FIELD CHANGE REQUEST (FCR) FORM

Project Name: Arkema Project Area – PDI Phase 2
Client: LSS/Retia USA

Project No.: CF167
Request No.: FCR-18

Field Change Request Title: Vibracore Step-Outs and Step-Ins to Delineate Chlorobenzene.

Figure 1.
Wide-view of the Proposed Remedial Design Investigation Sediment Sampling Stations Downstream of Dock 2

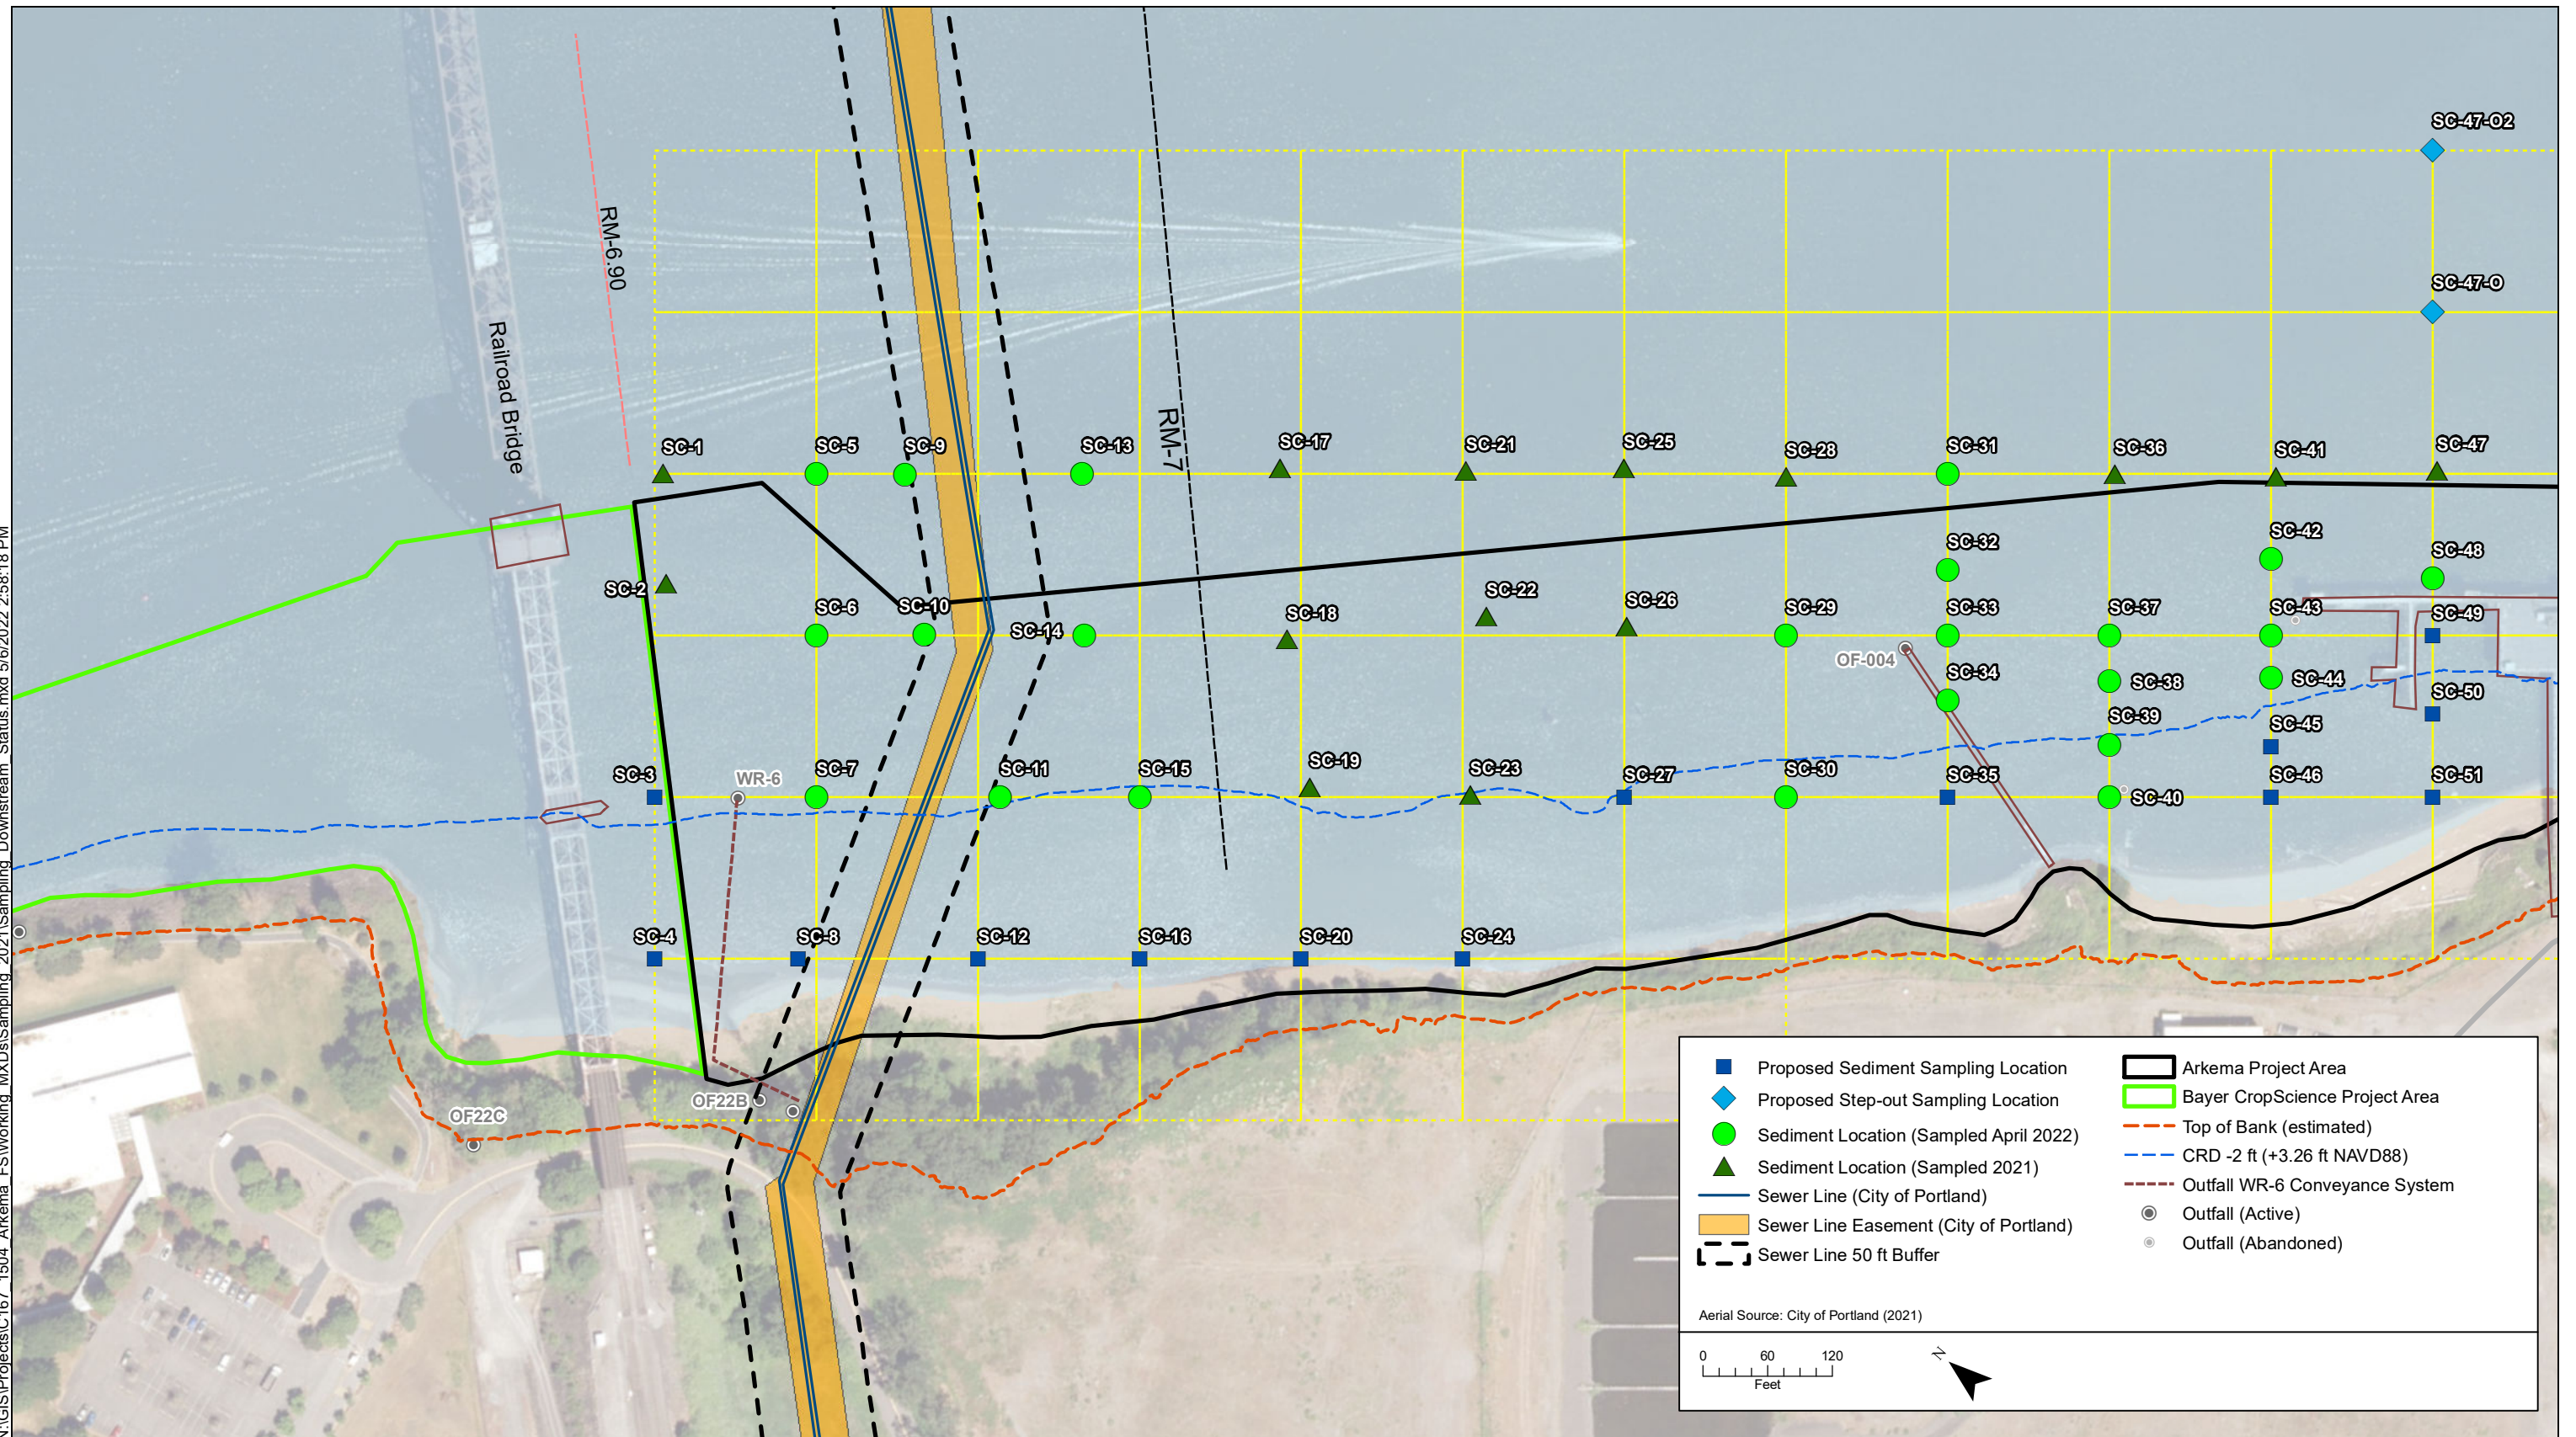
In accordance with FCR-17, another row of sediment vibracore stations was advanced toward the river channel. The additional stations (SC-52-0, SC-56-0, SC-60-0, SC-64-0, SC-67-0, and SC-70-0; Figures 1 and 2) were advanced to sampler refusal using the protocols developed in the approved PDI work plan (Section 4.5.1 of the Field Sampling Plan (FSP), Appendix A to the PDI Work Plan) and related approved FCRs. Each 1-ft interval from these cores was analyzed for chlorobenzene by EPA Method 8260C in accordance with the PDI Work Plan. The preliminary chlorobenzene results from these step-out cores warranted additional step-outs and step-ins to further delineate the lateral and vertical extent of chlorobenzene remediation threshold exceedances in the Dock 1 and 2 Reach.

Preliminary chlorobenzene data from the step-outs presented in FCR-17 show remediation threshold exceedances for chlorobenzene at stations SC-52-O, SC-56-O, SC-60-O, and SC-64-O. Additional step-out cores from these cores were warranted to delineate chlorobenzene remediation threshold exceedances at SC-47-O, SC-47-O2, SC-52-O2, SC-56-O2, SC-60-O2, SC-64-O2, and SC-67-O2 (Figures 1 and 2). Additionally, a step-out at SC-72-O was warranted to bound the upstream extent of the chlorobenzene remediation threshold exceedances (Figure 2).

The additional step-out cores were advanced to refusal and each 1-ft interval from these cores was analyzed for chlorobenzene by EPA Method 8260C in accordance with the PDI Work Plan. Preliminary chlorobenzene data show no chlorobenzene remediation threshold exceedances for the bottom three sample intervals from additional step-out cores SC-56-O2, SC-60-O2 and SC-64-O2. "Step-in" cores were warranted to further bound the chlorobenzene remediation threshold exceedances at stations SC-56-O1, SC-60-O1, and SC-64-O1 (Figure 2). The step-in cores were advanced to refusal and each 1-ft interval from these cores was submitted to the analytical laboratory for chlorobenzene analysis by EPA Method 8260C in accordance with the PDI Work Plan. The chlorobenzene results will be evaluated when they are available. If additional cores are recommended, the locations will be provided to EPA for approval with a reference to this FCR.
